Memo

From: Nicholas van den Berg	Email: nicholas.vandenberg@atkinsglobal.com
Date: 12 August 2022	Phone: N/A
Ref: 5150924DG0111	cc: Design Team

Subject: Adamstown Boulevard Phase 1 - RFI response

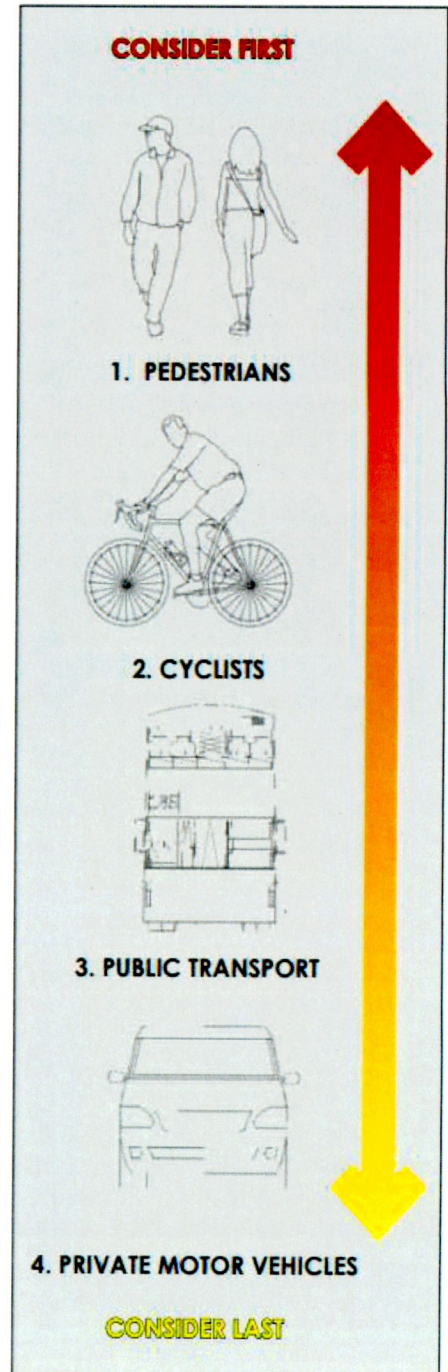
(a) A revised layout of not less than 1:200 showing a turning area at the end of Homezones adjacent to the linear park, or an autotrack showing vehicle manoeuvres to allow safe turning.

In conjunction with other design team disciplines we examined several turning head options in order to facilitate turning for each of the four homezones (refer to Drawing 5150924/HTR/SK/0001). Two issues were identified with all options:

1. Significant reduction in pedestrian and cycling connectivity. According to the Design manual for Urban Roads and Streets, designers must place pedestrians at the top of the user hierarchy (as shown in the figure alongside). The introduction of turning heads for the homezones would limit connectivity while introducing longer walking distances for pedestrians. This shown in the two figures below (pedestrian and cycling connectivity with and without the turning heads).

Revised Adamstown Way Junction

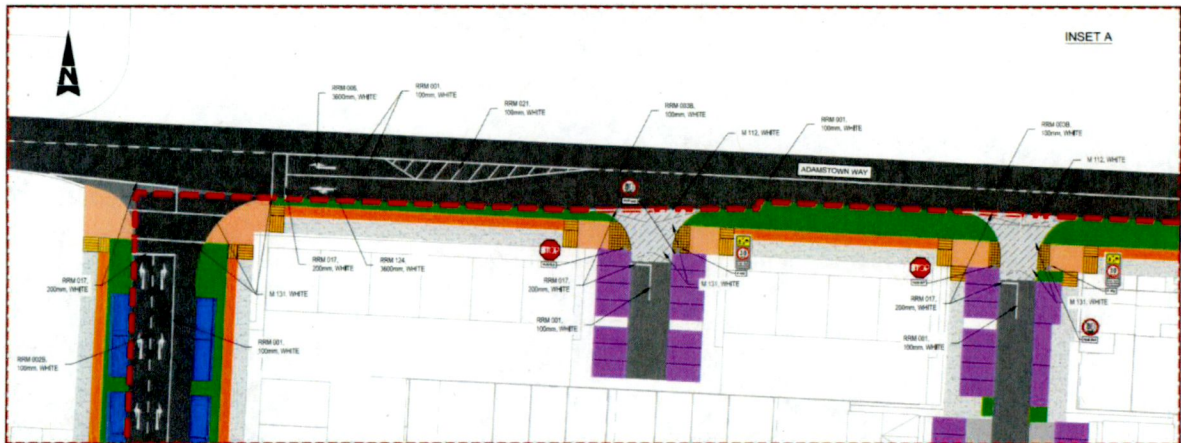
(b) A revised layout of not less than 1:200 showing the road layout for the vehicle access at the end with Adamstown Way.

The Adamstown Way junction has been revised in order to allow for vehicle access. The painted island was reduced and the RRM 001 (solid line) was converted to RRM0038 (dashed line) in order to allow for crossing. The revised layout is shown in the figure below.
